**CHURCH's #695**  
- 5407 Central NW -

DRIVEPADS

DWG. 2425

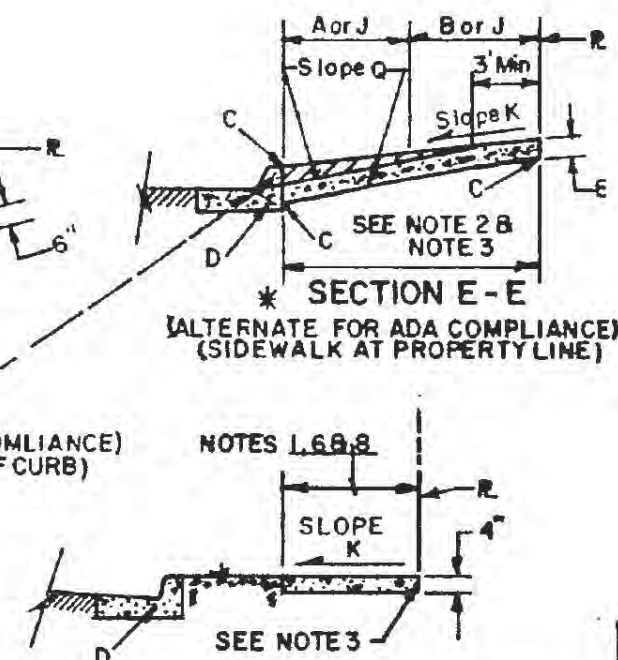
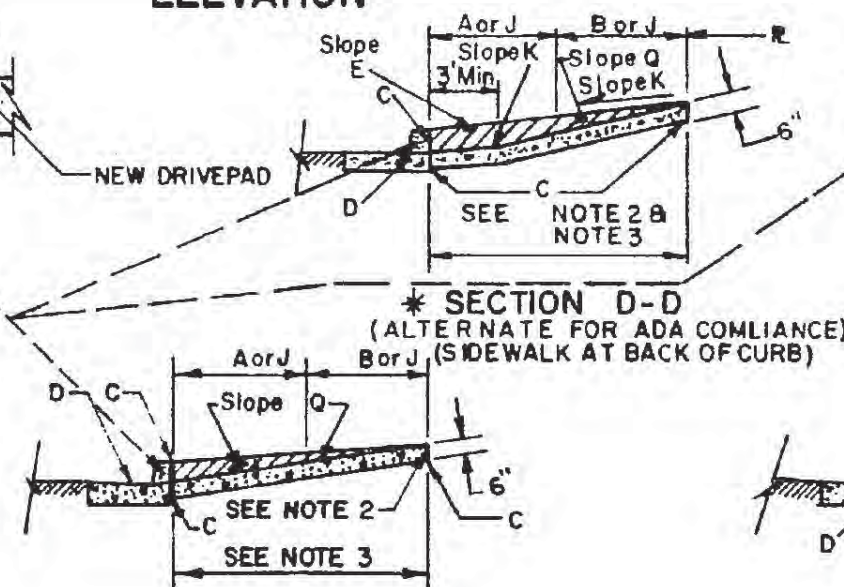
- Possible alternative driveway entrance, with flared ramp layout, and sidewalk pushed back into an easement on the property.

- You may be able to pull it all out into the R/W if R/W depth is adequate.
